Interchange A and C inputs of I79 for LVS

UPDATED Dec 17 08:28:44 2018	
DRAWN	cap_array3
CHECKED	
CHECKED	
CHECKED	SIZE D / CAGE NO. / DWG NO. / REV
ISSUED	SCALE / SHEET OF

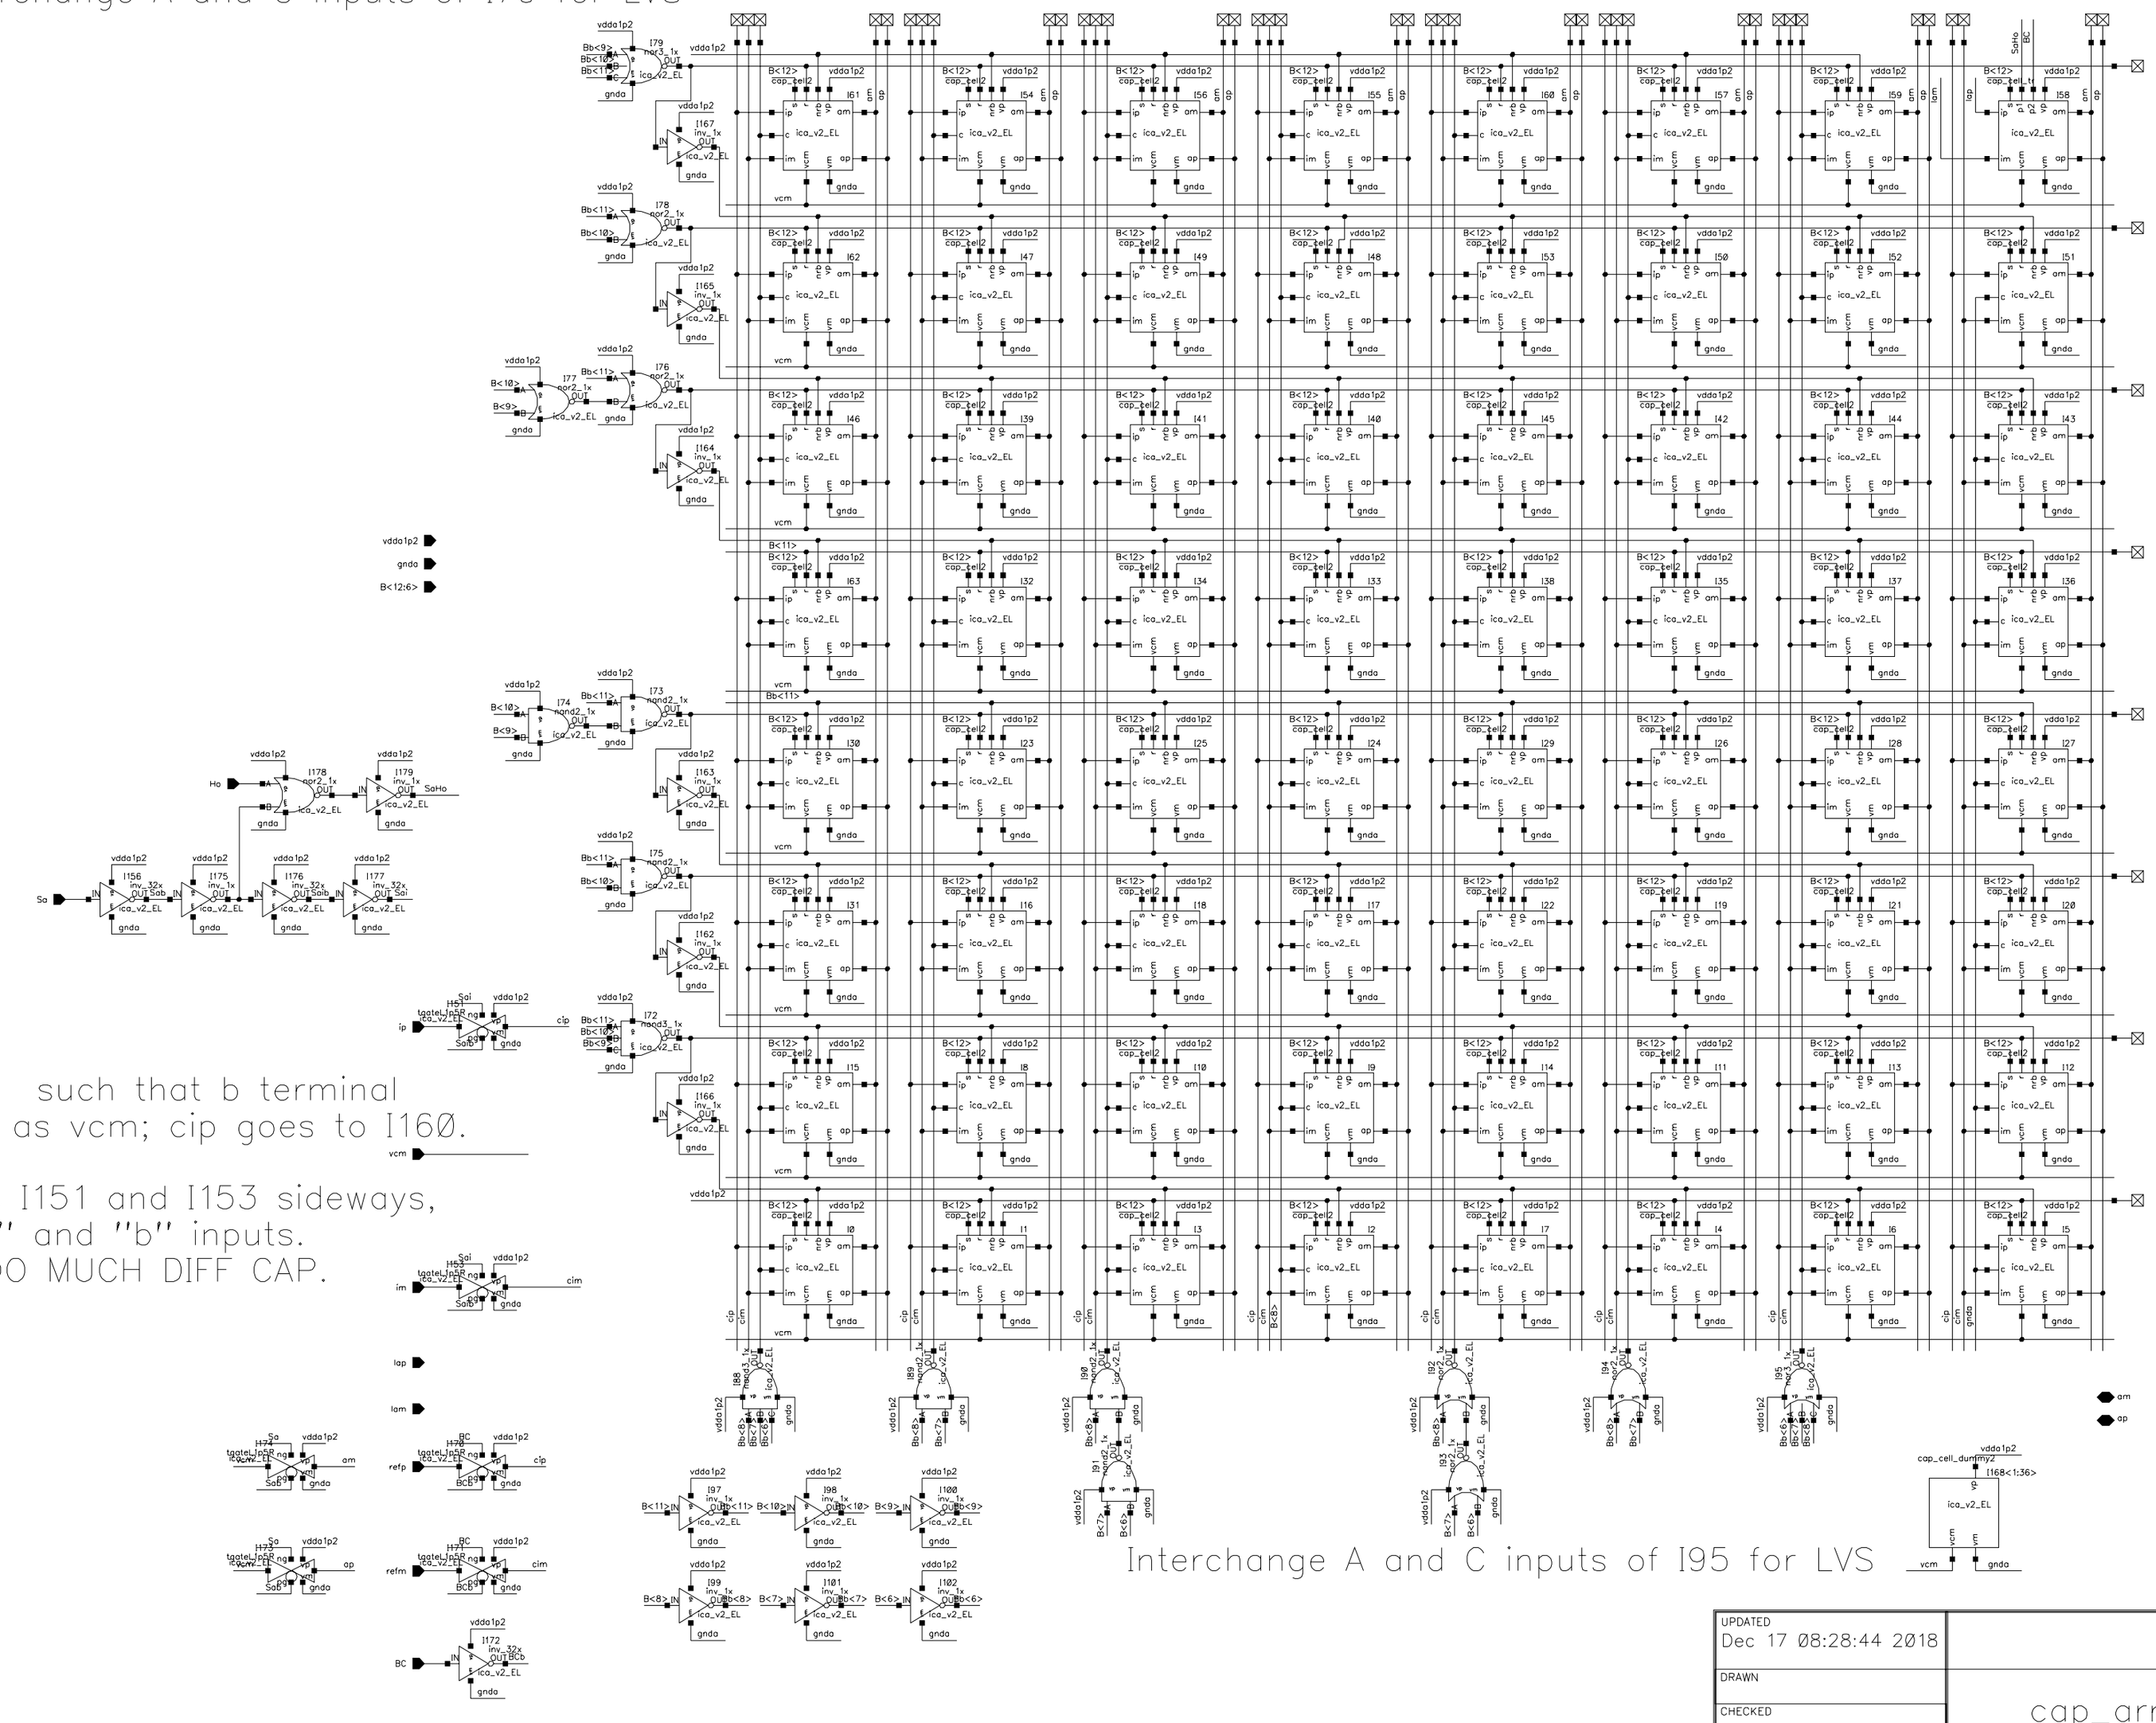
Exchange I160 and I161 such that b terminal is common and labeled as vcm; cip goes to I160.

LVS wants to flip I151 and I153 sideways, interchanging "a" and "b" inputs.
TG layout has TOO MUCH DIFF CAP.

Interchange A and C inputs of I95 for LVS
